## DSP-16033

Application	General Data	
<b>Project Name:</b> Stimulating Minds Child Development Center  <b>Location:</b> North side of Central Avenue (MD 332), between its intersections with Akin Avenue and Bayou Avenue.  <b>Applicant/Address:</b> Latrice Tibbs 400 Millwoof Drive Capitol Heights, MD 20743	Planning Board Hearing Date:	05/04/17
	Staff Report Date:	04/26/17
	Date Accepted:	02/23/17
	Planning Board Action Limit:	05/04/17
	Plan Acreage:	0.19
	Zone:	C-S-C/T-D-O
	Dwelling Units:	N/A
	Gross Floor Area:	2,036 sq. ft.
	Planning Area:	75B
	Council District:	07
	Election District	18
	Municipality:	Capitol Heights
200-Scale Base Map:	201NE05

SUBJECT: Detailed Site Plan DSP-16033  
Stimulating Minds Child Development Center

# SITE PLAN

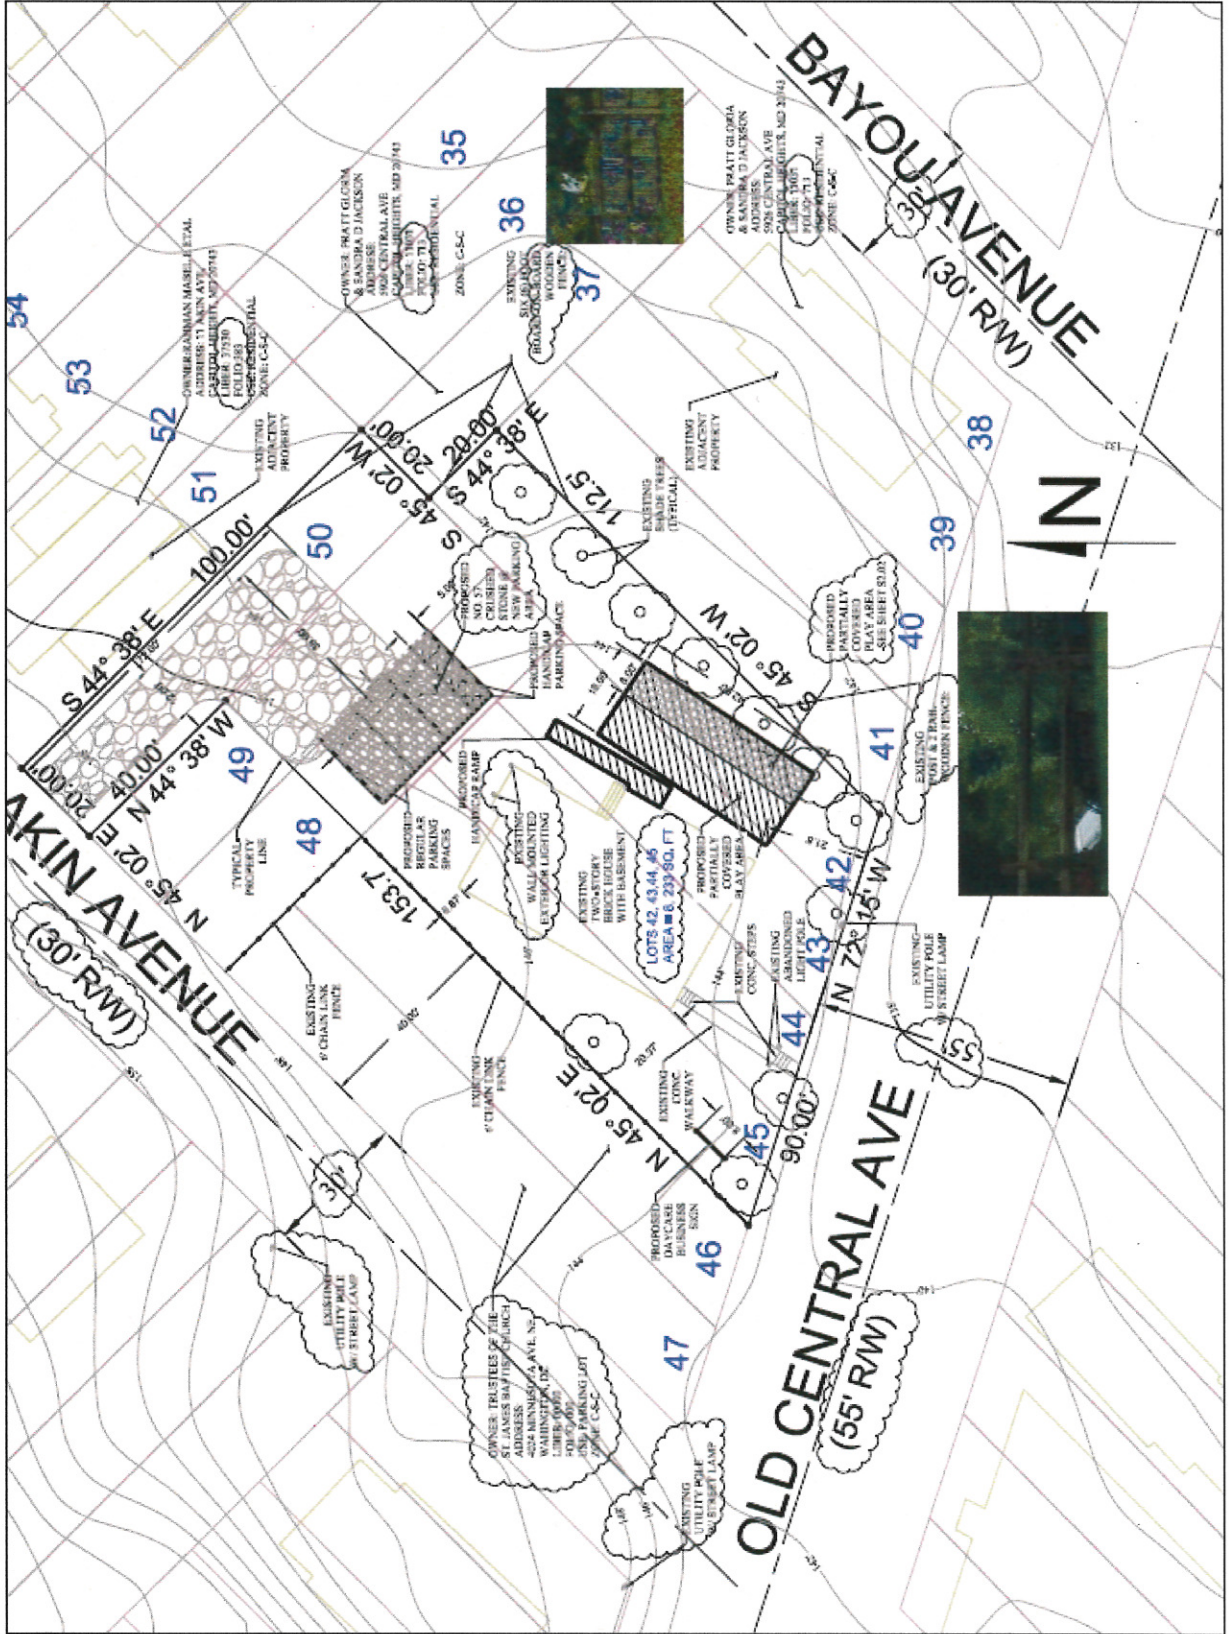
- a. Clarify or provide the following information on the site plan:
      - (1) Dimension the distance between the proposed play area and the nearest dwellings on adjacent lots.

- (6) Add the total height of the proposed canopy, including the gable roof.
  - (7) Ensure all line work and labeling is legible.
  - (8) Add the width of the paved area in front of the parking spaces.

- (9) Add the dimensions of the existing building.
  - (10) Indicate the walkway connection from the building to the right-of-way and the parking lot.

- b. Add site plan notes as follows:
    - (1) The hours of outdoor play will be limited to the hours between 7:00 a.m. and 9:00 p.m.
    - (2) The play area will not be used before or after daylight hours.

- c. Move the proposed freestanding sign outside of the ultimate planned right-of-way line, which is 12.5 feet behind the existing right-of-way line.

- d. Revise all references and labels for Old Central Avenue on the plans to Central Avenue (or alternatively MD 332), per Maryland State Highway Administration’s references.

- e. Provide evergreen shrubs along the western edge of the parking lot to screen it from Akin Avenue.
  - f. Provide one proposed shade tree adjacent to the proposed parking area.

- g. Provide a Section 4.9, Sustainable Landscaping Requirements, schedule demonstrating conformance to all requirements.
  - h. Add a minimum of one bicycle parking space close to the main entrance of the building.

- i. Provide an approved stormwater management concept plan and revise the DSP, if necessary.
